STAFF REPORT
COMMUNITY DEVELOPMENT DEPARTMENT

SUBJECT: Farmstone Crossing Subdivision AZ,
PP
[H-2023-0045](#)

LOCATION: 820 S. Black Cat Road in the Northwest
¼ of the Southwest ¼ of Section 15,
T.3N. R.1W.

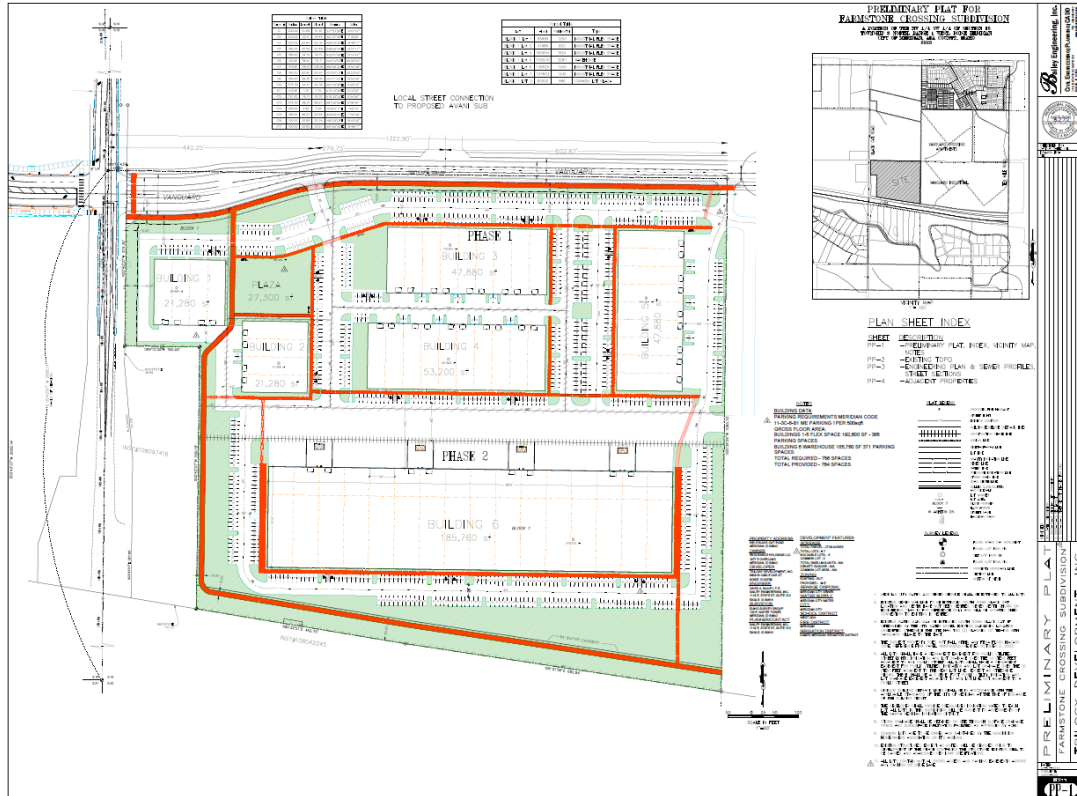
Vanguard Way should be constructed in accordance with Street Section C (major collector street) in the TMISAP, which requires (2) 11-foot travel lanes, 6-foot bike lanes, 8-foot parkways with streetlights at a pedestrian scale, and minimum 6-foot wide detached sidewalks (see pg. 3-20, 3-22, 3-23). The Applicant proposes a modification of the street section to include 10-foot wide detached sidewalks/pathways in lieu of on-street bike lanes, which is required by ACHD and as set forth in the Meridian Master Pathways Plan.

All streets should be constructed as complete streets as defined in the TMISAP (see pg. 3-19 & 3-20). Prior to submitting the final plat, the Applicant shall coordinate with the property owner to the north and east to construct Vanguard Way and deed the right-of-way to ACHD. The Applicant should ensure that the intersection of Vanguard Way and S. Black Cat Road aligns with the entrance of the Black Cat Industrial projects on the west side of S. Black Cat Road.

FIGURE 1

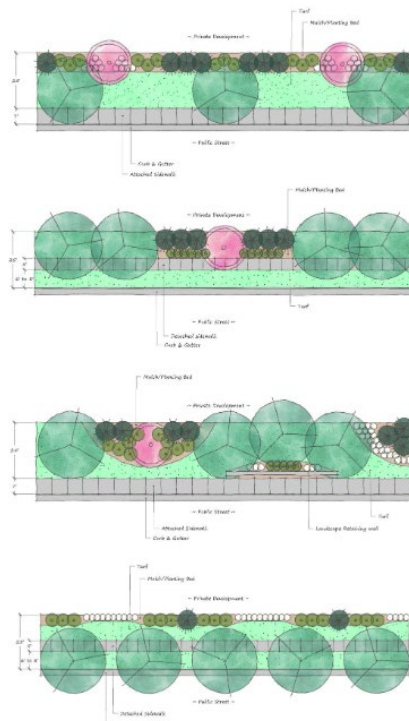
Street buffers are required to be provided as set forth in UDC [Table 11-2A-7](#). A minimum 25-foot wide street buffer is required along all arterial streets (i.e. S. Black Cat Road) in commercial districts. A 20-foot wide street buffer is required along all collector streets (i.e. Vanguard Way) – the buffer may be placed in an easement rather than a common lot in accord with UDC 11-3B-7C.2a. A minimum 50-foot wide street buffer is required along I-84, landscaped per the standards listed in UDC [11-3B-7C.3](#), which requires a variety of trees, shrubs, lawn or other vegetative groundcover (see updated code for specifics & figures below). **The proposed buffer dimensions appear to meet the requirements of the UDC code; however, there is a lack of a combination of planters (shrubs and rock mulch) within the buffer along Vanguard Way. The Applicant has provided fifty-two (52) trees and only thirty-four (34) are required along Vanguard Way. Staff recommends that the Applicant enhance the street buffer by reducing the number of trees and incorporating additional planters. The landscape buffer along Black Cat Road adjacent to the open drainage swale, lacks vegetation in front of the 10-foot pathway, not meeting the requirements of the UDC.**

The Applicant should revise the landscape plan to reflect landscaping within the required buffers along Vanguard Way and Black Cat Road adjacent to the drainage swale in front of the 10-foot pathway in accordance with the standards listed in UDC [11-3B-7](#), which requires a variety of trees, shrubs, lawn or other vegetative groundcover (see figures below).

- a. Depict landscaping within required street buffers along Black Cat Road adjacent to the drainage swale in front of the 10-foot pathway and Vanguard Way in accord with the recently amended standards listed in UDC [11-3B-7C and 11-3B-8C](#); all required landscape buffers along streets shall be designed and planted with a variety of trees, shrubs, lawn, or other vegetative ground cover. Plant materials in conjunction with site design shall elicit design principles including rhythm, repetition, balance, and focal elements

D. Landscape Plan Rendering

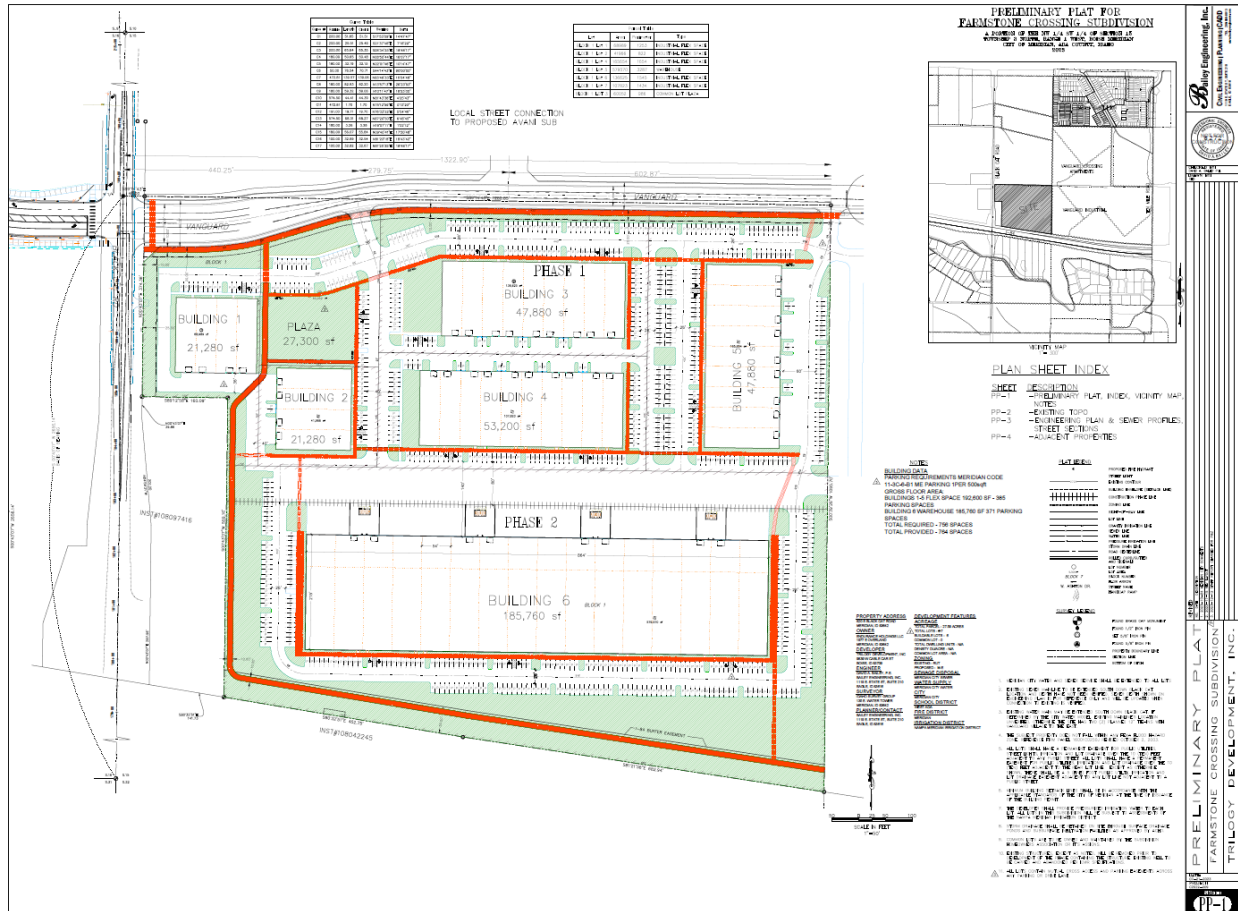
Mitigation is required for all existing trees 4" caliper or greater that are removed from the site in accord with the standards in UDC 11-3B-10C.5. Mitigation calculations are depicted on the landscape plan in accord with UDC standards (i.e. 149 trees at 2 caliper inches each for a total of 284 caliper inches). **The location of mitigation trees shall be depicted on a revised landscape plan submitted with the final plat application.**

- c. The location of mitigation trees shall be depicted on a revised landscape plan submitted with the final plat application.
- 2.4 A 14-foot wide public use easement for the multi-use pathways within this site shall be submitted to the Planning Division prior to submittal for City Engineer signature on the final plat(s).

E. Pedestrian Circulation Plan

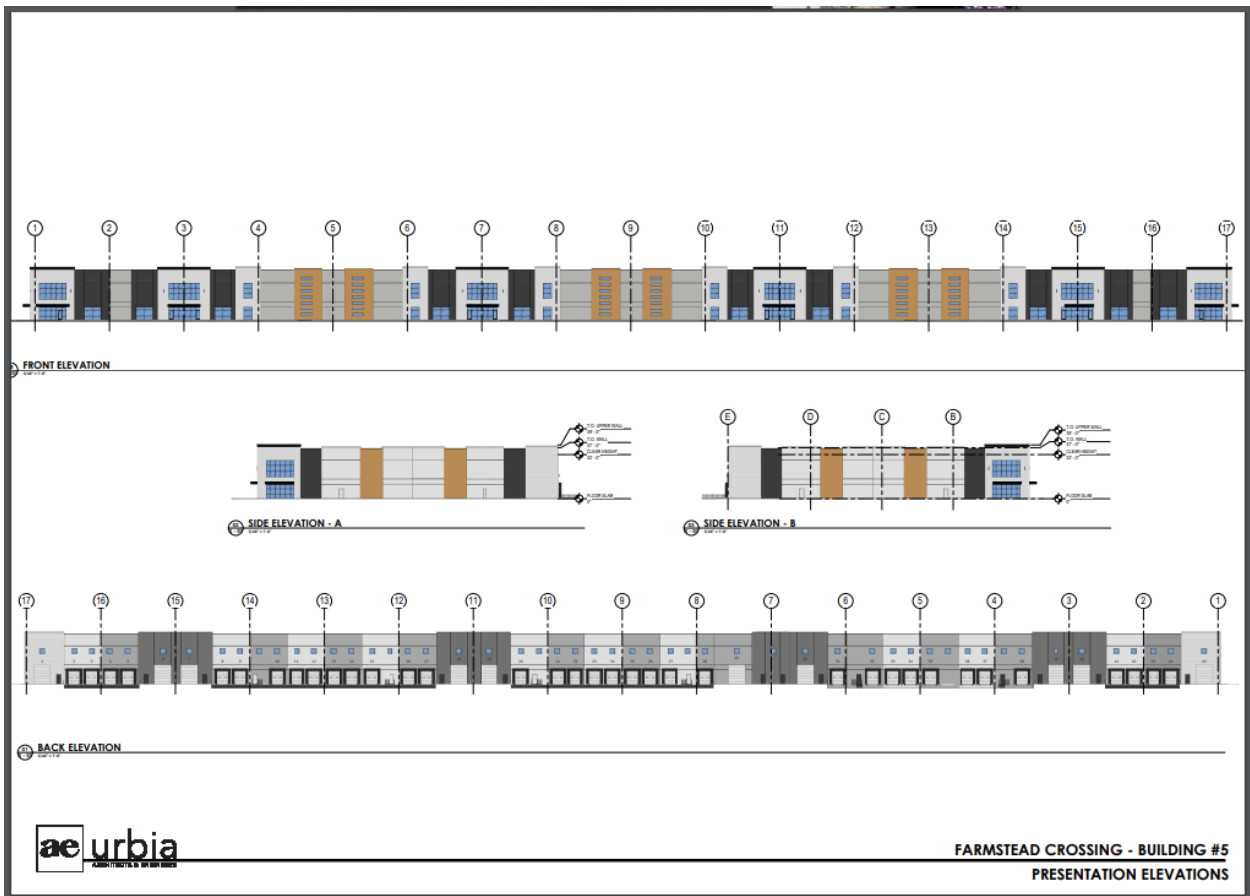
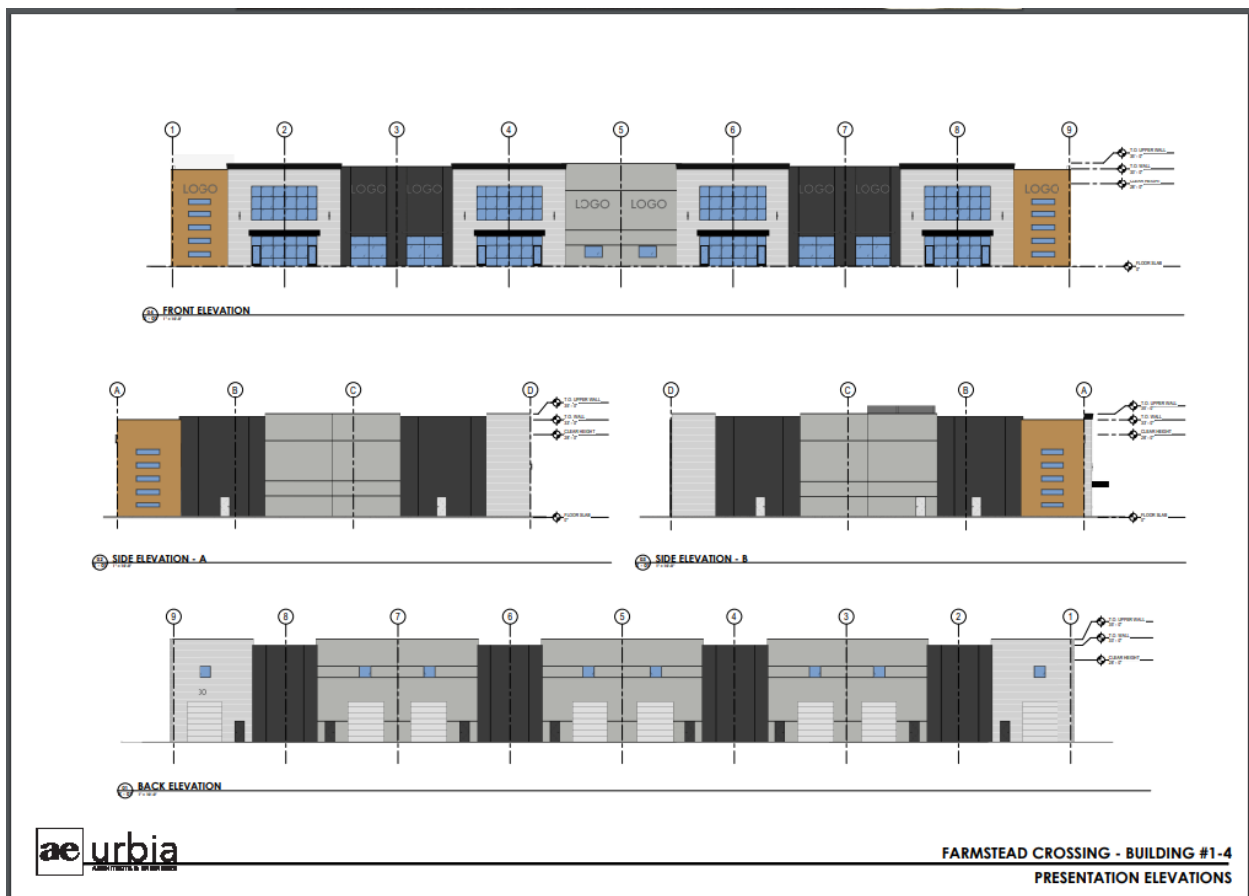
Ten (10) foot-wide multi-use pathways are proposed on the site in accordance with the Pathways Master Plan. One segment follows Vanguard Way across the northern portion of this site; one segment runs along the southern boundary within the street buffer along I-84; and another segment runs along the west side of the site adjacent to S. Black Cat Road to the plaza on the north. **The proposed pathway is intended to cross the drive aisle between Buildings 1 & 2**

(refer to figure below). Staff recommends removing the loading docks from the rear of Buildings 1 & 2 to mitigate potential conflicts between pedestrians using the pathway and delivery trucks accessing that area. A 14-foot wide public use easement for all multi-use pathways shall be submitted to the Planning Division prior to submittal for City Engineer's signature on the final plat(s).

- a. Development of the subject property shall be generally consistent with the site plan, landscape plan, preliminary plat, phasing plan, and conceptual building elevations included in Section VII and the provisions contained herein. **Prior to the Council hearing, the Applicant shall provide elevations for Building #1 and Building #2 incorporating a more traditional office design to complement the plaza area. Additionally, the Applicant shall remove the loading docks from the rear of the buildings in favor of more parking.**
